**METROPOLITAN GOVERNMENT OF NASHVILLE AND DAVIDSON COUNTY**

**STAFF RECOMMENDATION**  
**2100 Twentieth Avenue South**  
**November 16, 2016**

**Application:** New construction-addition  
**District:** Belmont-Hillsboro Neighborhood Conservation Zoning Overlay  
**Council District:** 18  
**Map and Parcel Number:** 10412015200  
**Applicant:** Tucker Tingle, Allard Ward Architects  
**Project Lead:** Paul Hoffman, paul.hoffman@nashville.gov

<p><b>Description of Project:</b> Construction of a rear addition with attached garage.</p> <p><b>Recommendation Summary:</b> Staff recommends approval with the conditions:</p> <ol style="list-style-type: none"><li>1. The porch columns be redesigned with doubled wood columns on a stone pedestal, matching the original porch columns;</li><li>2. Staff approve masonry prior to purchase and installation;</li><li>3. Staff approve the color of roofing material, and final details, dimensions and materials of windows, doors and garage doors prior to purchase and installation; and,</li><li>4. If they are moved, HVAC and other utilities shall be located on the rear façade, or on the non-street-facing side of the house.</li></ol> <p>With these condition

Figure 2. Existing window openings to be removed or resized

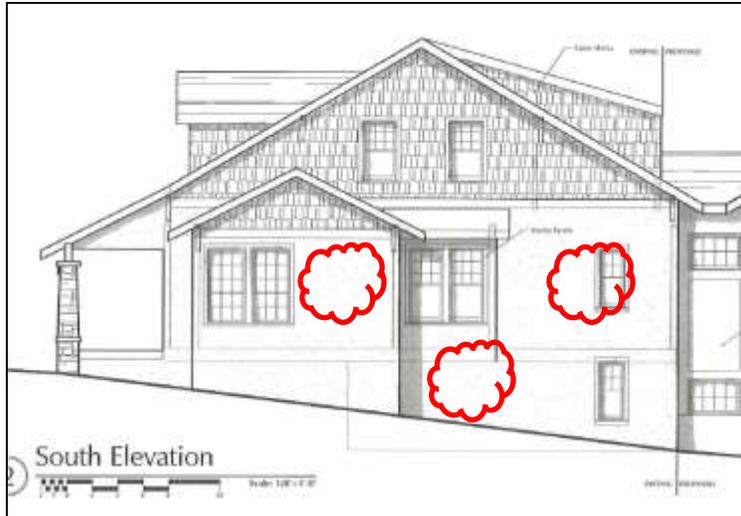
Two windows and a triple window on the right side are proposed to be filled in (Figure 2). Staff finds changing the windows openings on this side to be appropriate, as the forward-most window is not an original opening, the second is at the basement level which is not a character defining window, and the third is also not an original window opening and is at the rear of that side. The existing window sashes will likely be replaced.

Figure 3. Historic photograph shows the porch columns had paired wood columns and stone pedestals

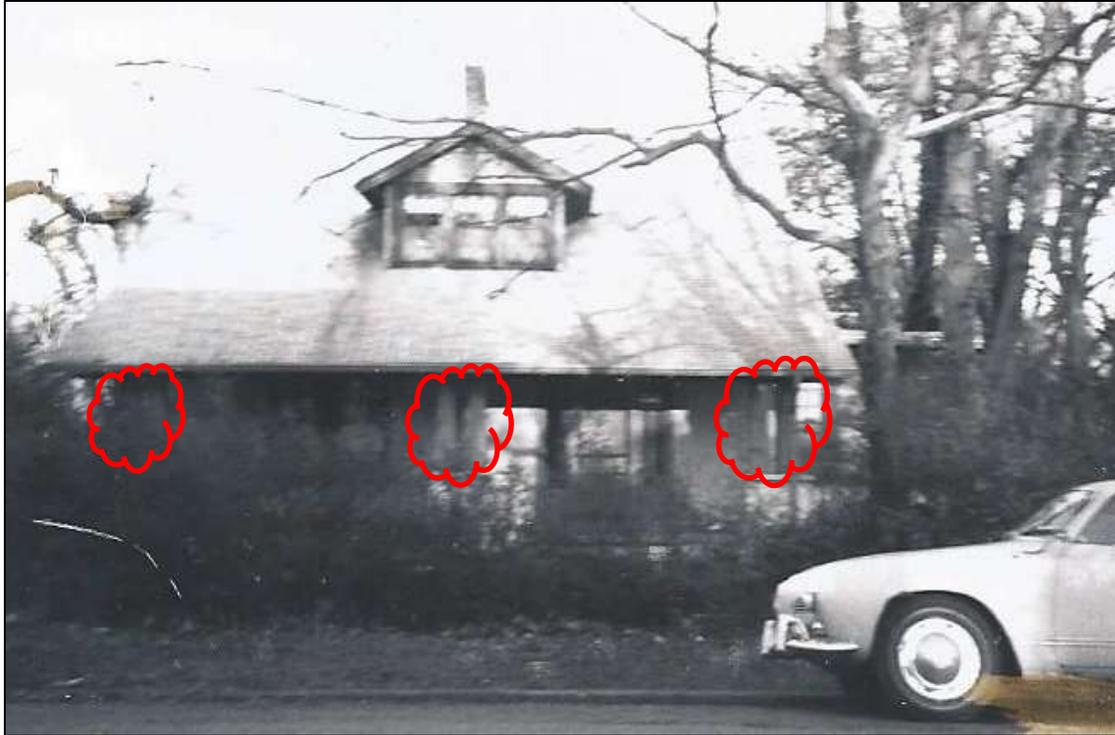
The reconstructed front porch is planned with tapered stone posts on stone pedestals. Staff located an historic photograph indicating that the porch originally had paired tapered wood posts on stone pedestal. Staff therefore recommends a condition that the new porch columns be redesigned to match the original porch posts.

1. The porch columns be redesigned with paired tapered wood columns on stone pedestals, matching the original porch columns;
2. Staff approve masonry prior to purchase and installation;
3. Staff approve the color of roofing material, and final details, dimensions and materials of windows, doors and garage doors prior to purchase and installation; and,
4. If they are moved, HVAC and other utilities shall be located on the rear façade, or on the non-street-facing side of the house.

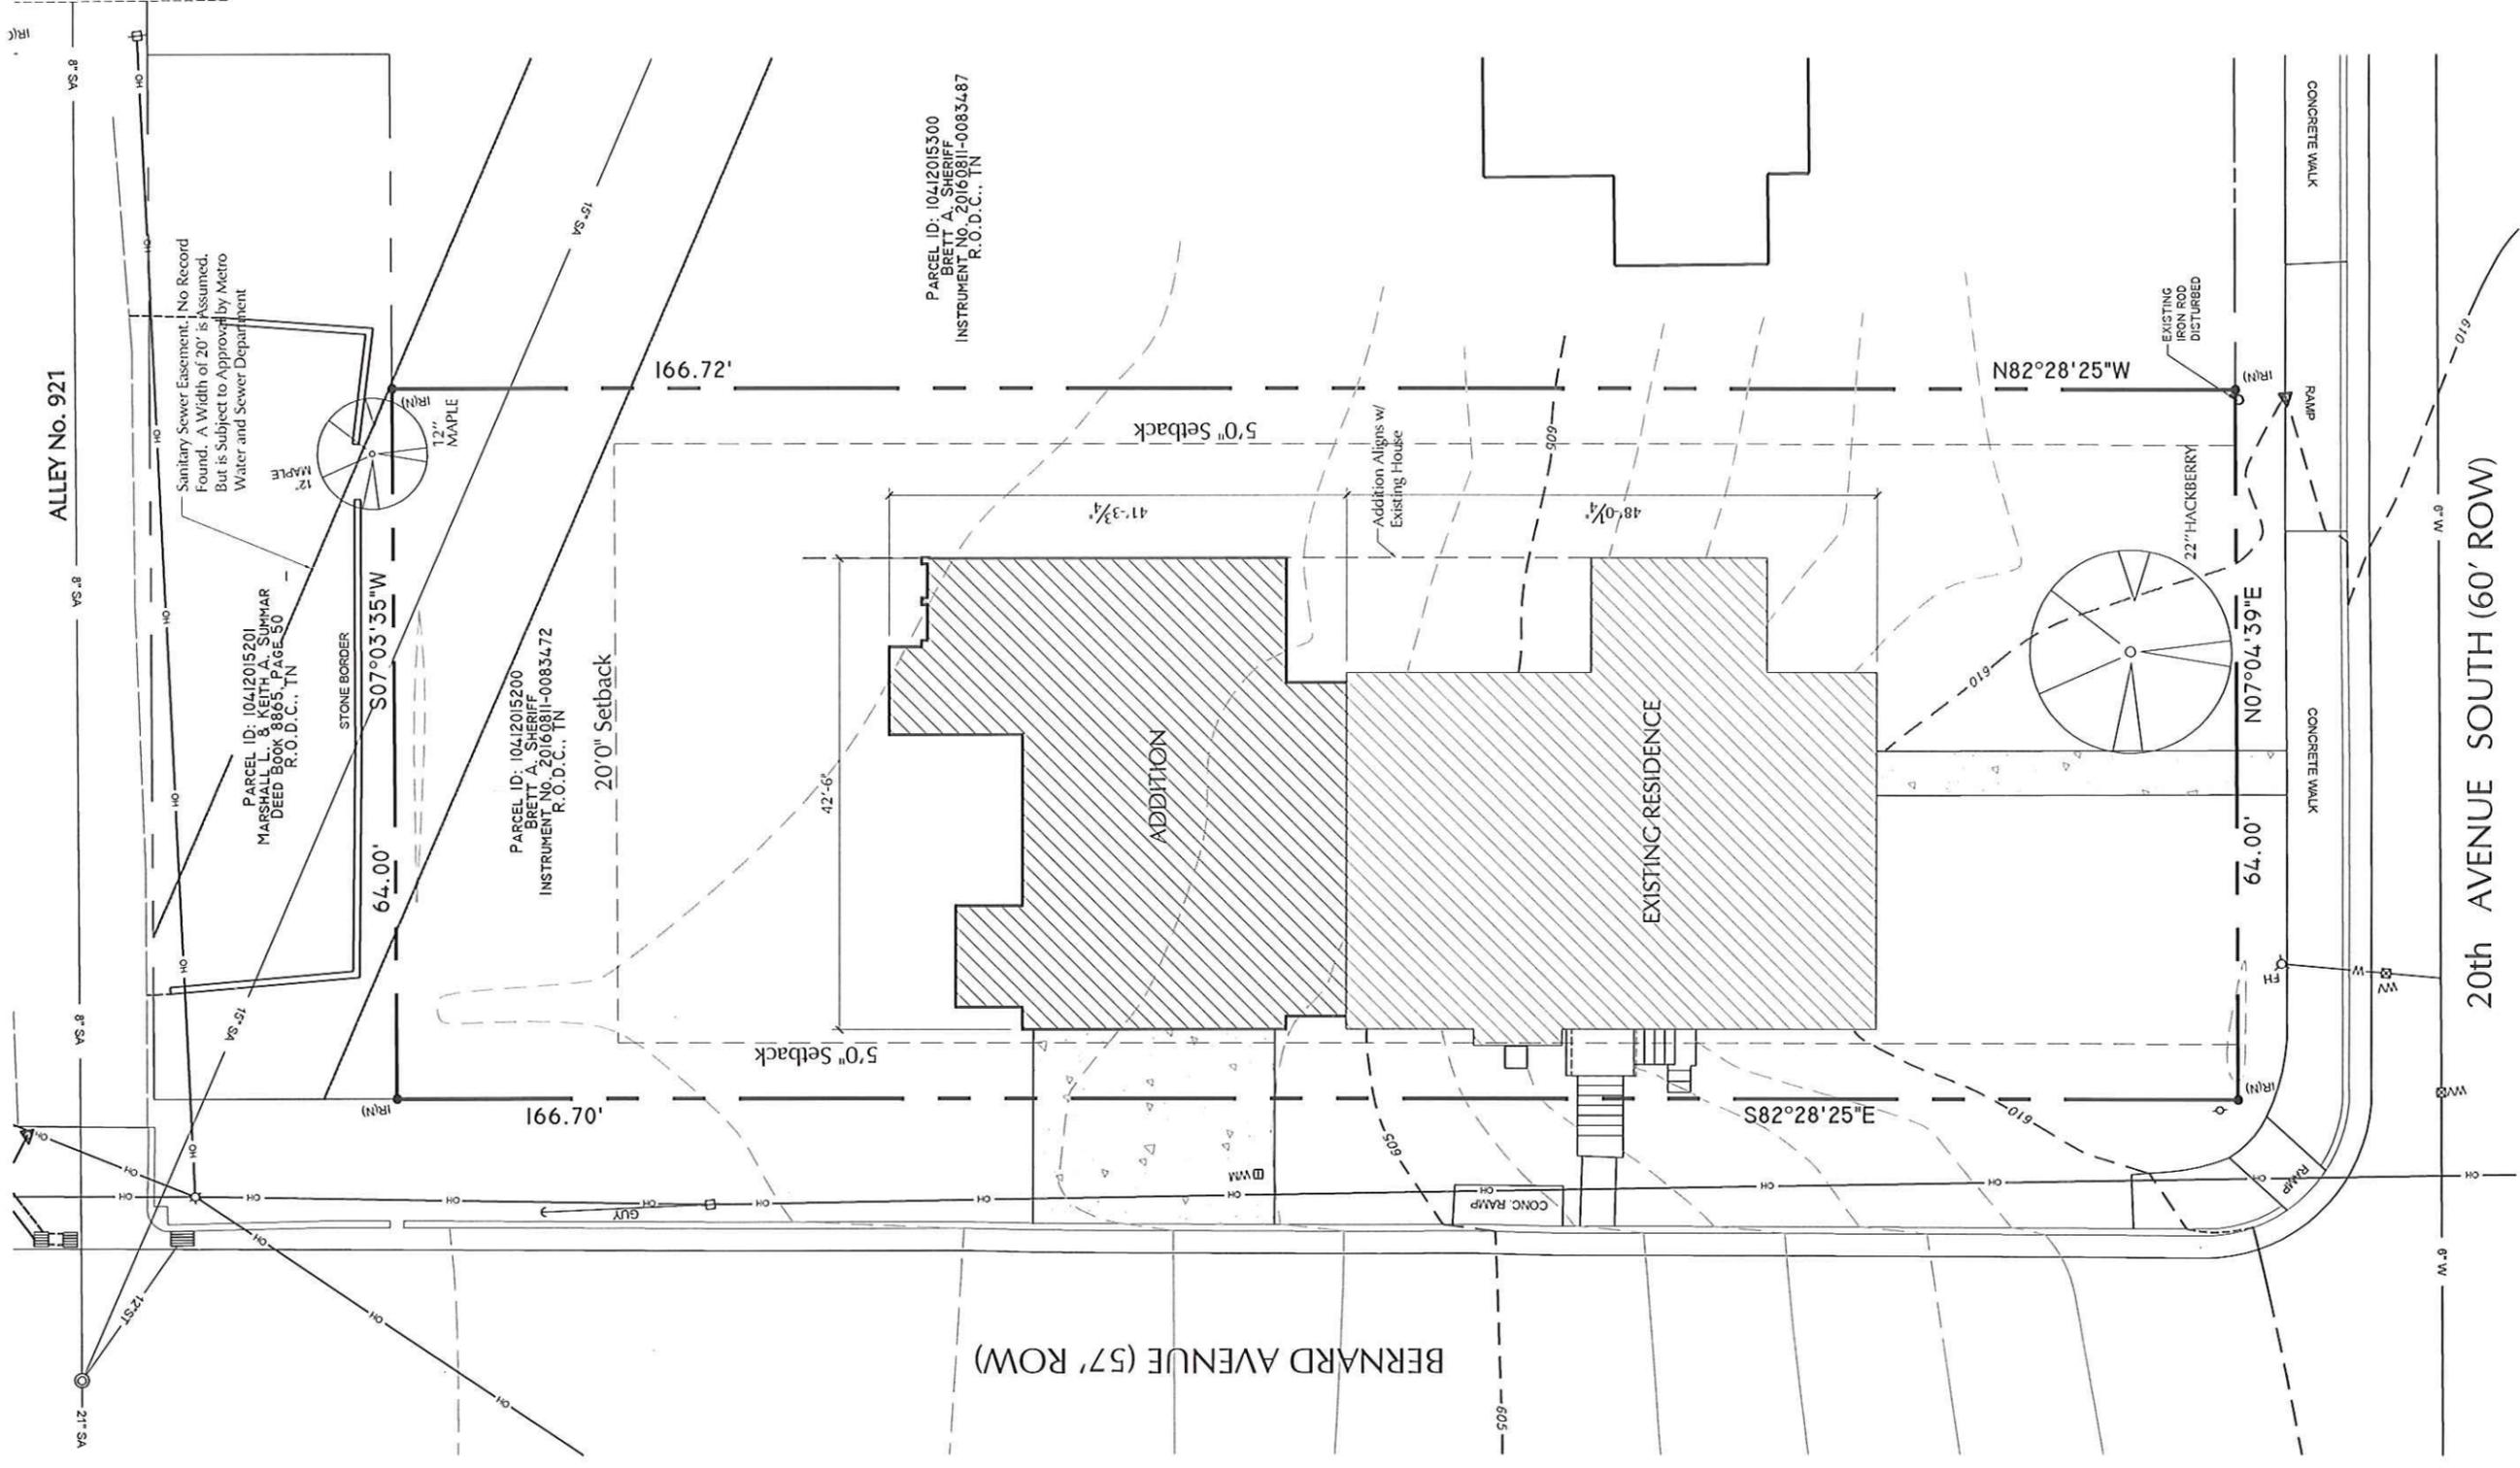
Appurtenances & Utilities: A concrete driveway and walkway will be added, both of which are appropriate. The site plan and floor plans do not indicate that utilities are being relocated. If HVAC or other utilities are moved, Staff recommends that they be located on the rear façade, or on the non-street-facing side of the house, to meet the design guidelines for minimal visibility of utilities. With this condition, the project will meet section II.B.1.h.
